SIB 64 04 25

**SERVICE ACTION: HARNESS DAMAGE POSSIBLE WHILE CHANGING CABIN NANOFILTER**This Service Information Bulletin (Revision 2) replaces SI B64 04 25 **dated April 2025**.

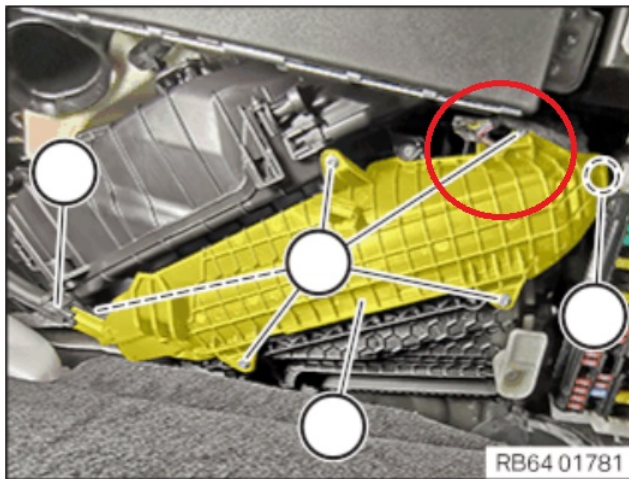
When following Repair Instructions REP **64 31 010** to change the cabin air nanofilter, check the vehicle wiring harness routing (circled) before fastening the plastic cover over the filter.

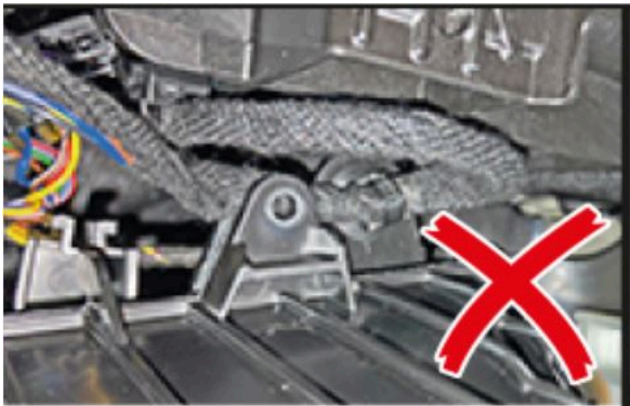
This is where the harness can be damaged when installing the cabin air filter cover screw.

This shows the harness damage; the sheathing has been abraded.

With the harness pulled out of the way, you can see the screw mounting hole for the cabin air filter cover.

Double check the routing of the harness prior to installing the screws for the cabin air filter cover.

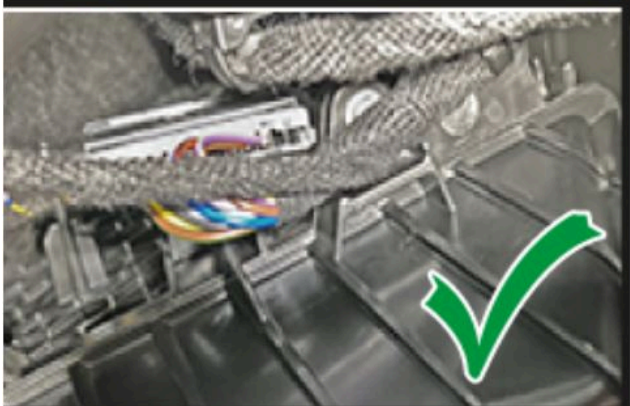
If the wiring harness has already been damaged during the installation of the cabin air filter cover, the damaged section of the wiring harness must be repaired.

The original harness retainer must be disconnected. This is shown by the red arrow below. It can be left clipped into vehicle but must be disconnected from harness for strain relief.
